ADDENDUM

No. 03 Date: 9/11/2024
Project No. 0020711.01 Attention: Leonard D'Souza
Project Name: Princess Margaret Cancer Centre
Stem Cell Transplant 2, MHC, MHDU, DSC
Address: University Health Network
610 University Avenue
Toronto ON

This Addendum forms a part of the Bidding and Contract Documents and modifies the original issued Bidding Documents (dated August 13, 2024) for the above titled project, as indicated below, and is hereby incorporated into the Contract Documents as part thereof.

A0504

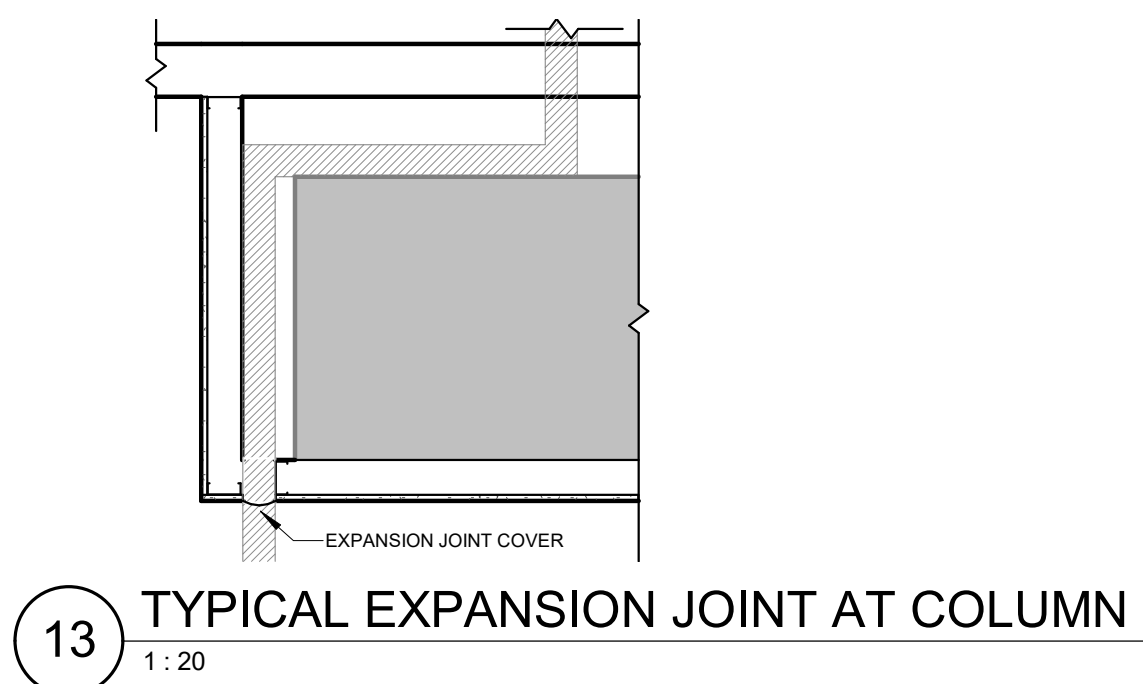
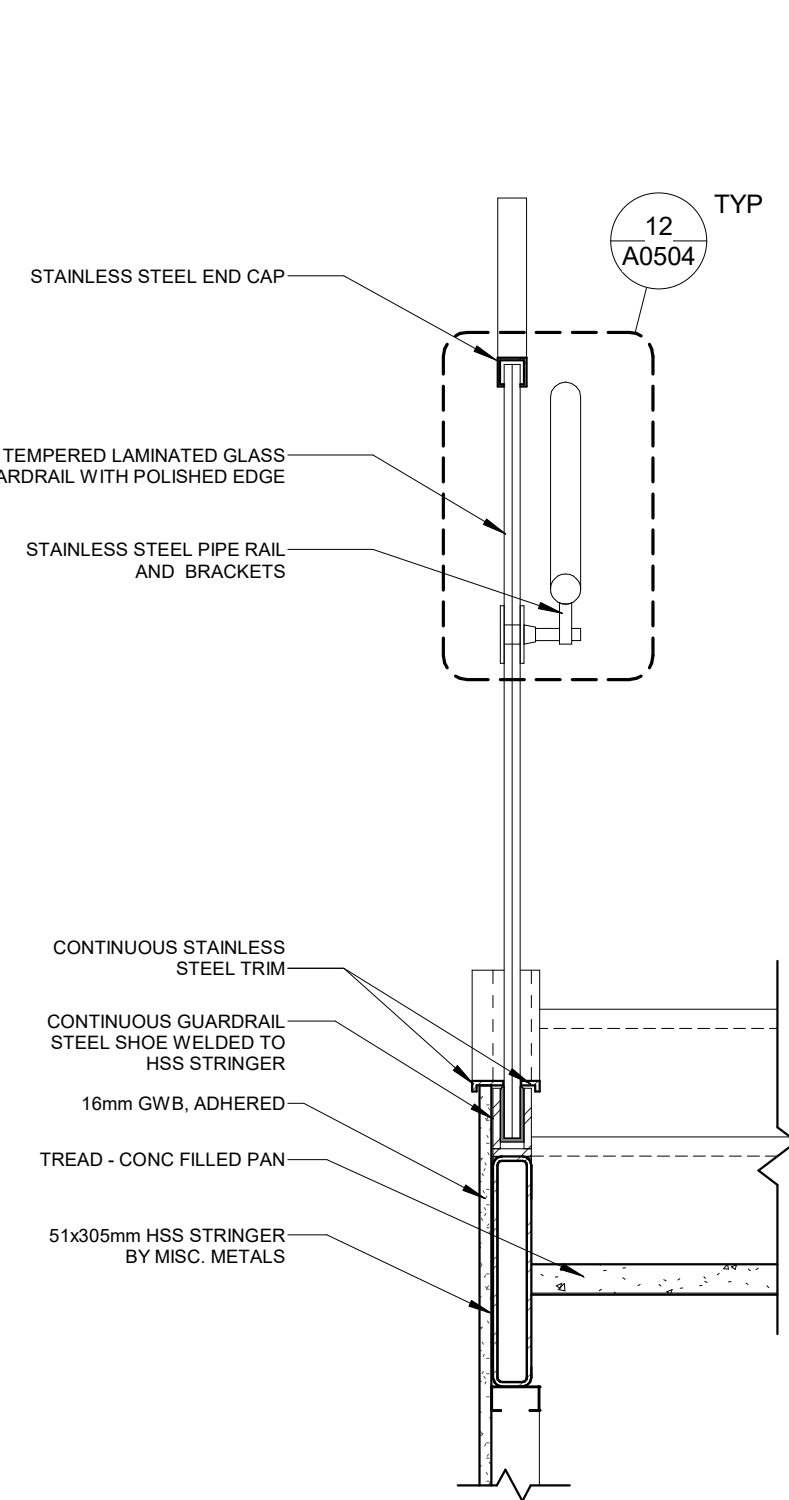
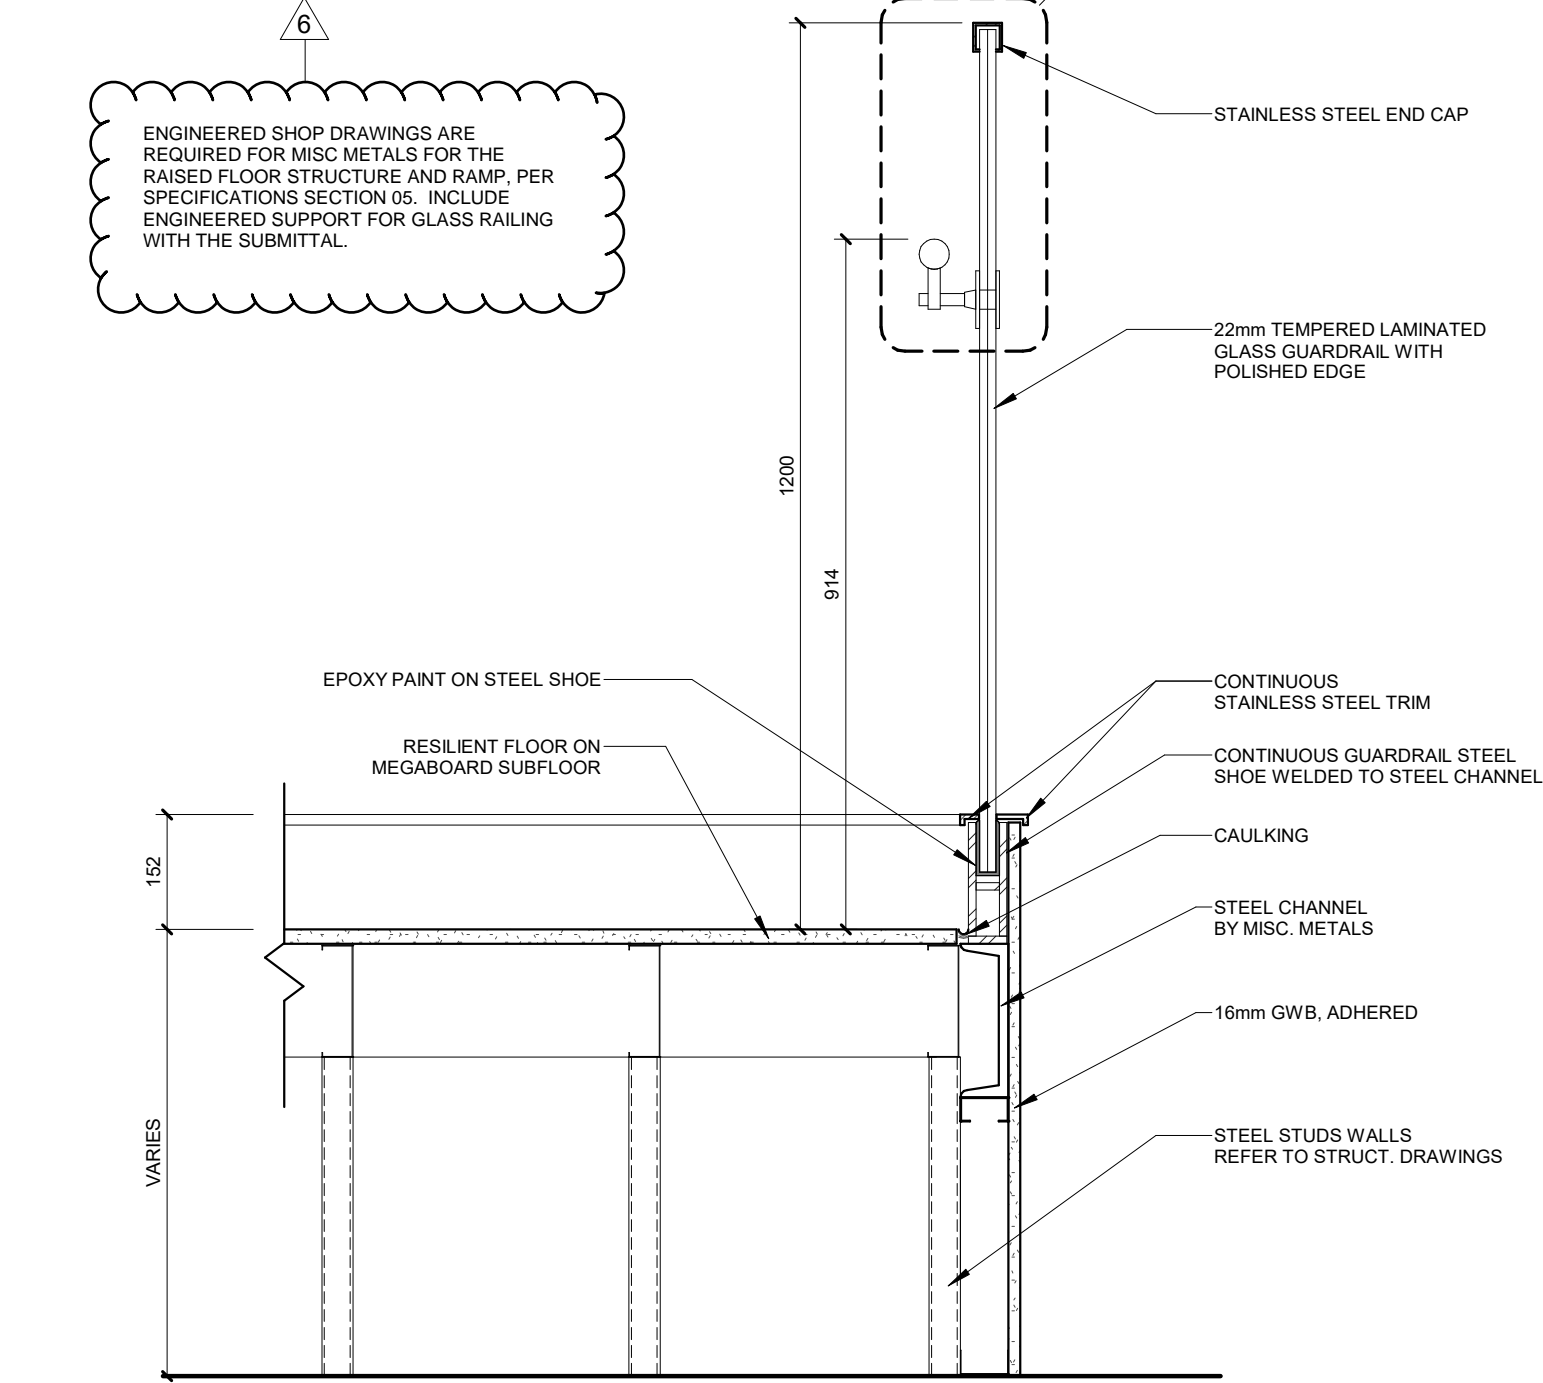
DRAWING G0504 – RAMP & STAIR DETAILS

Added note that glass guard support be included in the engineered shop drawings for raised floor and ramp area.

**REFLECTED CEILING
PLAN - LEVEL 01**

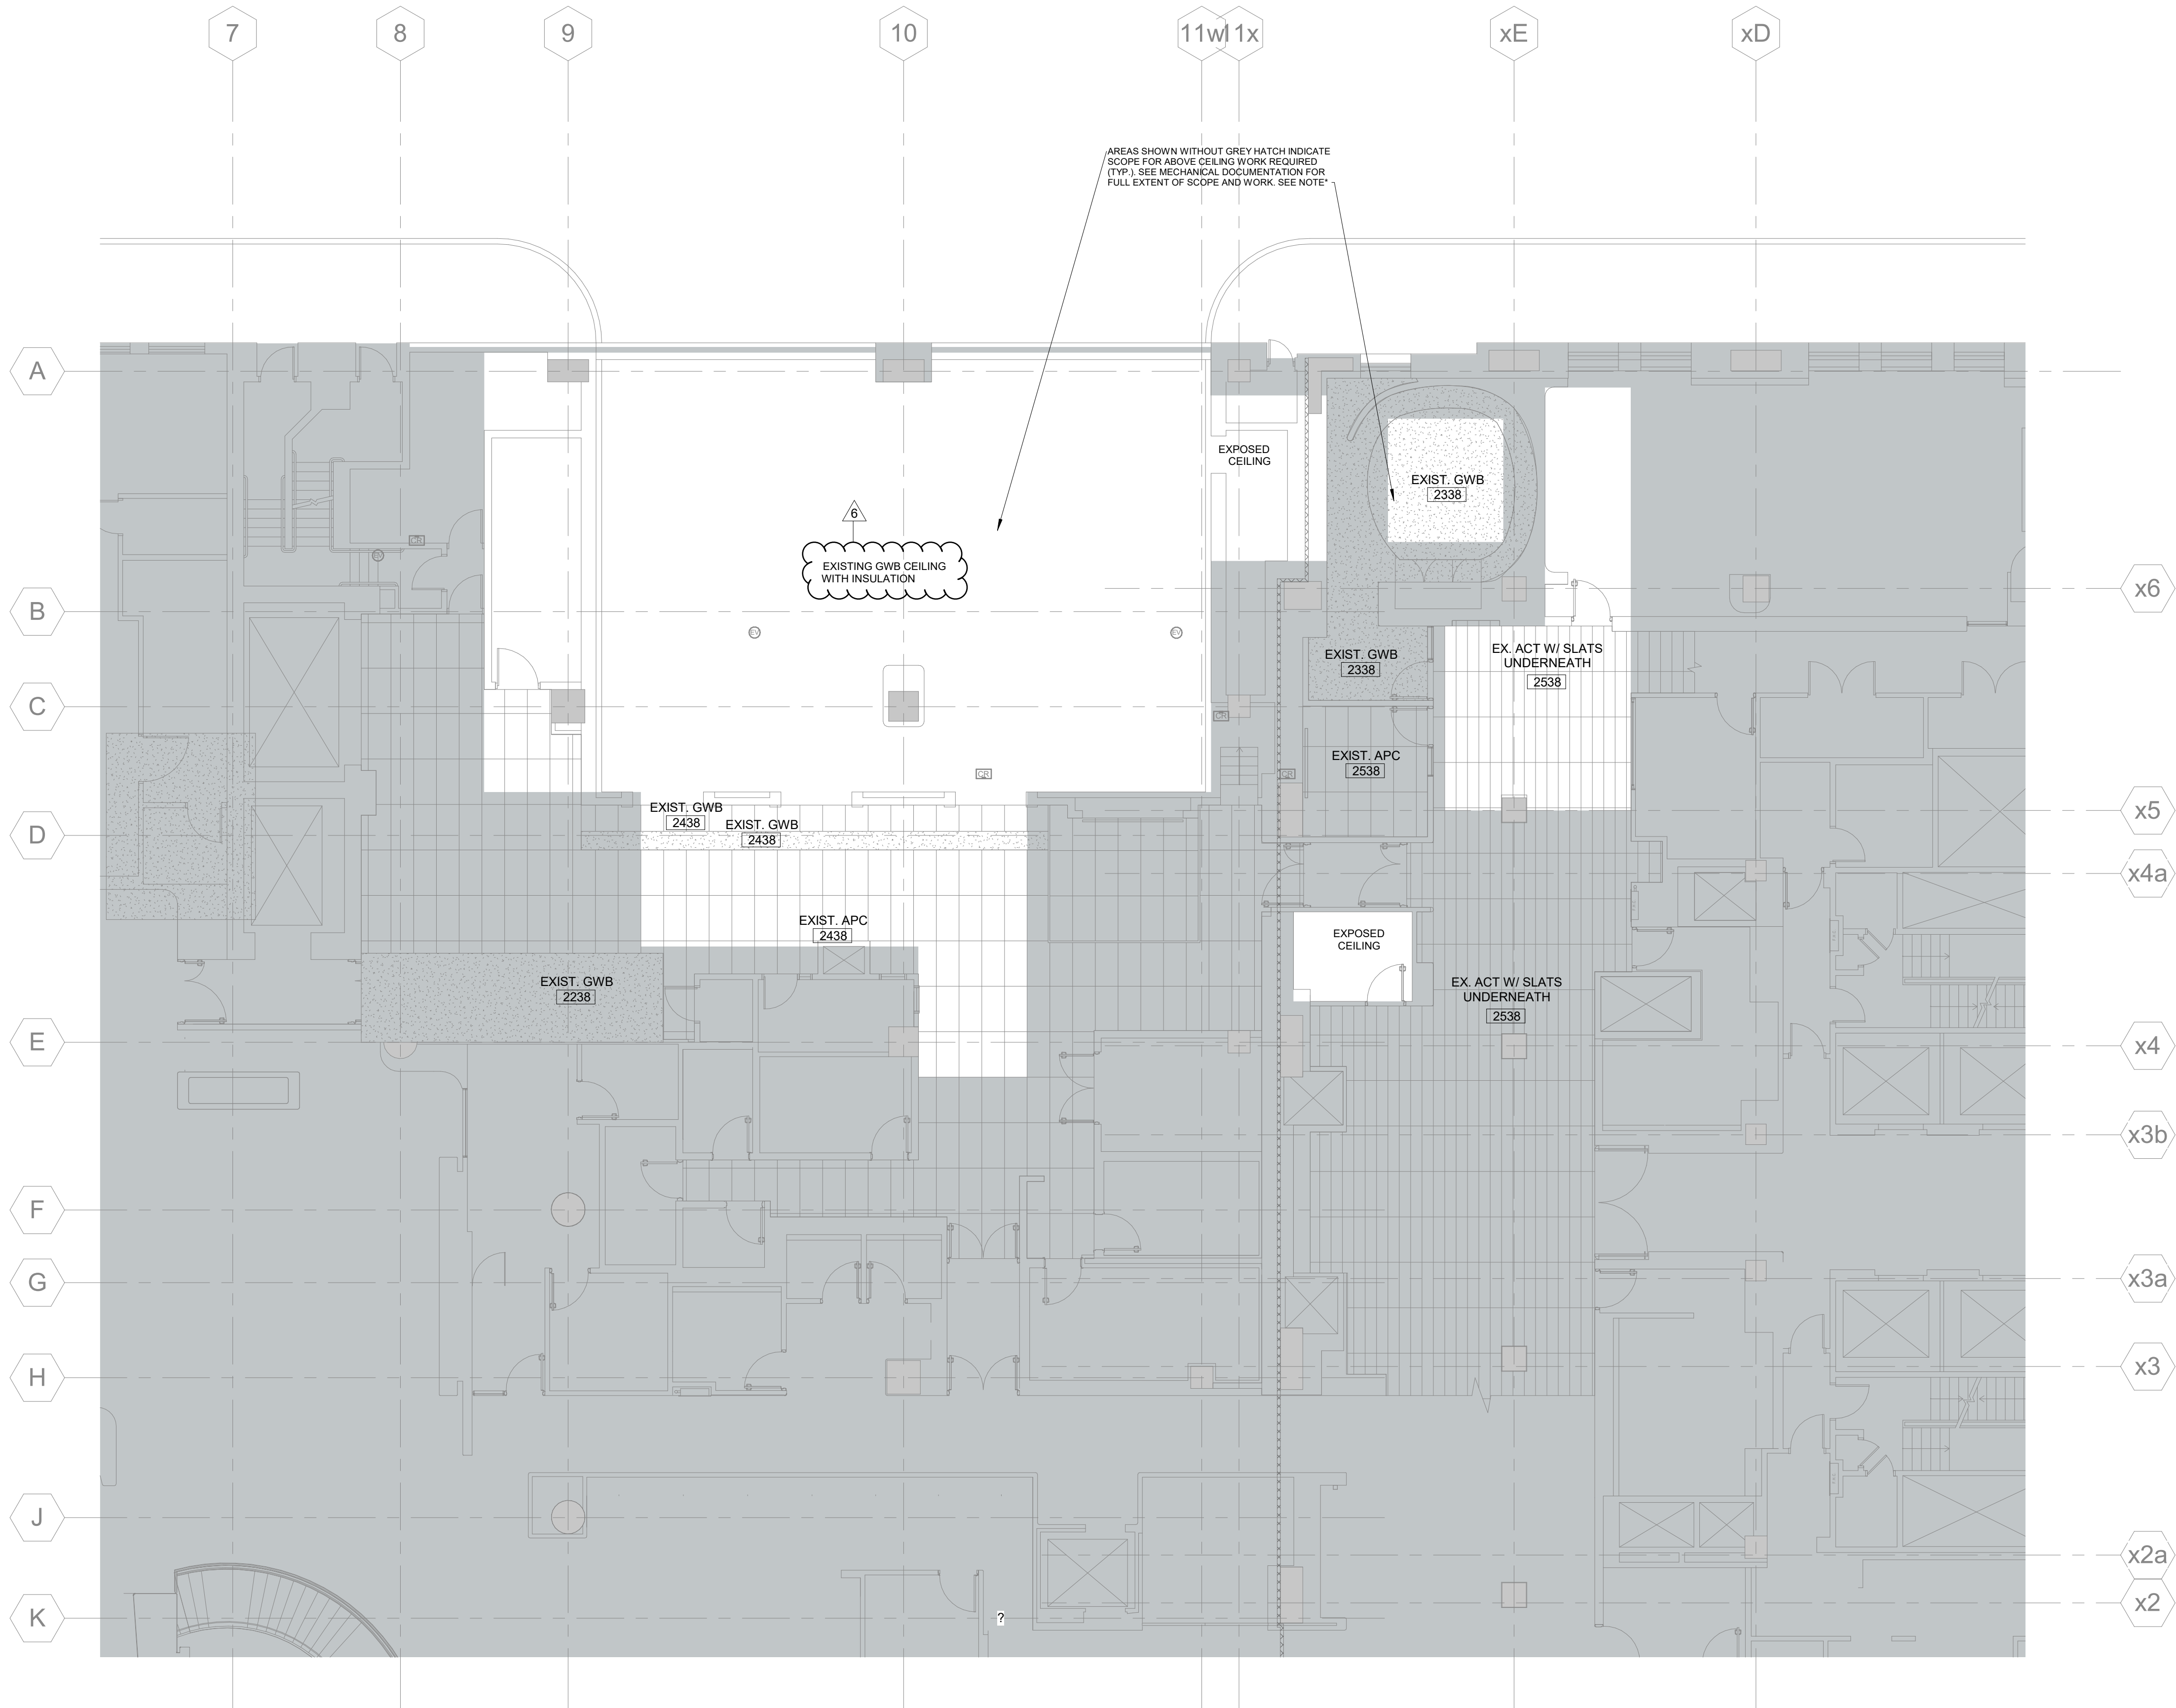
DRAWING G0701A – REFLECTED CEILING PLAN - LEVEL 01

Revised ceiling type in loading dock area.
